Flight Procedures Cover Page	Task Action: FLIGHT CHECK	Task Type: SID	Estimated Chart Date: 09/03/2026	APWS Task ID: 6F1B4453B6214F4EA31B8B978007395E	APWS Project ID: 7E36E542A7DD45EA9280F90A152F748D
Procedure: KATZZ THREE DEPARTURE (RNAV)		Enroute: YES	Specialist: Palmer, Leo		Agreement Number:
Airport ID: KDFW			Airport City: DALLAS-FORT WORTH		State: TX
Facility ID:	Facility Type:	Flight Inspection Remark Type: New FC Slot

PROCEDURE: KATZZ THREE DEPARTURE (RNAV)		AIRPORT NAME: DALLAS-FORT WORTH INTL		AIRPORT ID: KDFW	SPECIAL CONTROL NO: OG-03-146-26
FAC ID: KATZZ3		CITY: DALLAS-FORT WORTH		ST: TX	ORIG CHART DATE: 09/03/2026
DFL TYPE: PROC/D	THIRD PARTY: <input type="checkbox"/> YES	EST. TIME ON SITE: 1.0	REIMB. NUMBER:	PTS TASK ID: 6F1B4453B6214F4EA31B8B978007395E

KATZZ TWO DEPARTURE (RNAV)

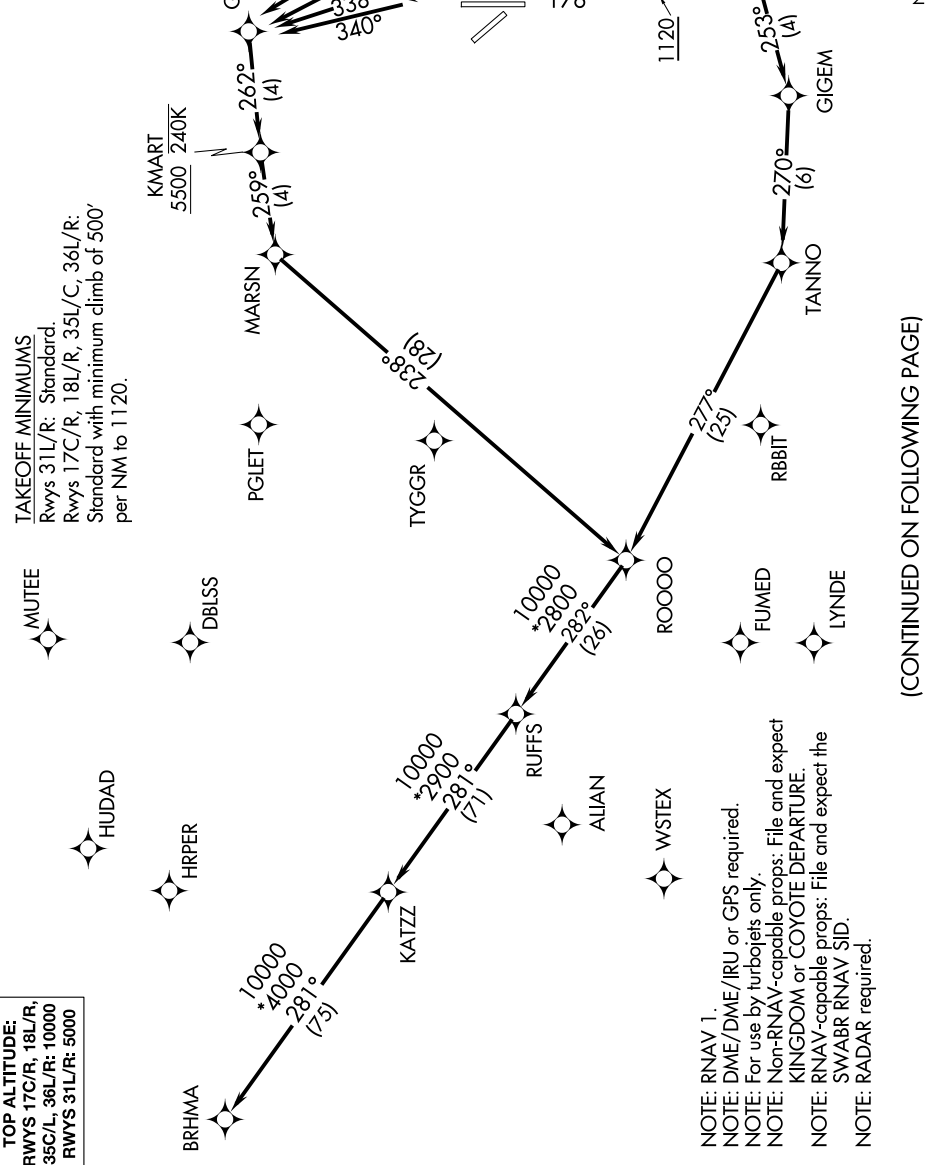
1. DP ROUTE DESCRIPTION: RWY 17C, 17R, 18L, 18R, 35C, 35L, 36L, 36R, REMOVED RUNWAY TRANSITION DESCRIPTION AFTER FIRST TF LEGS, LARRN AND KMART. - PER AFS.
2. COMMON ROUTE: RWY 17C, 17R, 18L, 18R, 35C, 35L, 36L, 36R, REMOVED COMMON ROUTE DESCRIPTION AND REPLACED WITH "THEN ON DEPICTED ROUTE TO KATZZ" - PER AFS.
3. COMMON ROUTE: RWY 31L/R, REMOVED COMMON ROUTE DESCRIPTION AND REPLACED WITH "THEN ON DEPICTED ROUTE TO KATZZ" - PER AFS.
4. PROCEDURAL DATA NOTES: REMOVED "NOTE: NON-RNAV-CAPABLE PROPS: FILE AND EXPECT KINGDOM OR COYOTE DEPARTURE.", "NOTE: RNAV-CAPABLE PROPS: FILE AND EXPECT THE SWABR RNAV SID." - PROCEDURE DESIGNATED FOR USE BY TURBOJETS. - PER AFS.
5. FIXES AND/OR NAVAID: REMOVED IAW 8260.46 DOCUMENTATION STANDRAD - NOT ALLOWED ON RADAR VECTOR SID. - PER AFS.
6. REMARKS: REMOVED RECCOMENDED NAVAID PGO. - NO LONGER REQUIRED ON RNAV SID. - IAW 8264.46 DOCUMENTATION STANDARDS.

1. DEPARTURE ROUTE DESCRIPTION: RWY 31 L/R ROUTE DESCRIPTION, AND ROUTE CONTINUATION COMBINED WITH ALL RUNWAYS. - PER AFS
2. REMARKS: ADDED "WAIVER ON FILE FOR RWY 31 L/R VECTORS BELOW THE MVA.". - ADDITIONAL WAIVER REQUIERED PER AFS.

1. RWY 31 L/R DEPARTURE ROUTE DESCRIPTION AND CODING CHANAGED FROM "CLIMB HEADING ASSIGNED BY ATC, FOR VECTORS TO ROOOO, THENCE..." TO "TAKEOFF RWY 31L: CLIMB ON HEADING 315.06 TO 1109, FOR VECTORS TO ROOOO, THENCE...." AND "TAKEOFF RWY 31R: CLIMB ON HEADING 311.28 TO 1109, FOR VECTORS TO ROOOO, THENCE...." 8260.15C CODING CHANGED FROM VM/DF TO VA/VM. - PER AFS - IAW 8260.46K 3-1-6 B (3).
2. REMARKS: ADDED WAIVER ON FILE FOR ATC REQUESTED MAINTAINED ALTITUDE LOWER THAN THE UNRESTRICTED CLIMB ALLOWED BY TERPS EVALUATION", - ADDITIONAL WAIVER REQUIRED PER AFS
3. REMARKS: REMOVED "WAIVER ON FILE FOR TERMINOLOGY USED IN DP ROUTE DESCRIPTION FOR RWY 31L/R (CLIMB HEADING ASSIGNED BY ATC)." - PER AFS NO LONGER REQUIRED, SUPPORTED BY CRITERIA
